# Access Compliance Report

## Public Rights-of-Way

### (Curb Ramps)

Intersection ID: 10917	Main Street: E_25TH_ST	Cross Street: N_DAVIDSON_ST	Location: N
ADA ID: AE140ABFD0AB	Ramp Type: BlendTrans1	Initial Pass/Fail: Fail	Overall Compliance: No
Severity Score: 10			
Codes/Mitigation Info/Possible Solution		Field Measurements/Component Compliance

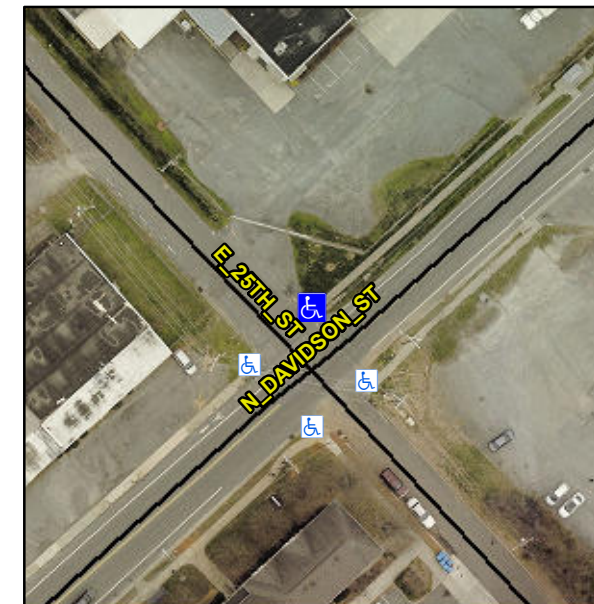
**RP < 5%, NO CURB**

**R304.5.1, R304.5.3**

**Remove & Replace Curb Ramp With Two New Directional Ramps or Equivalent.**
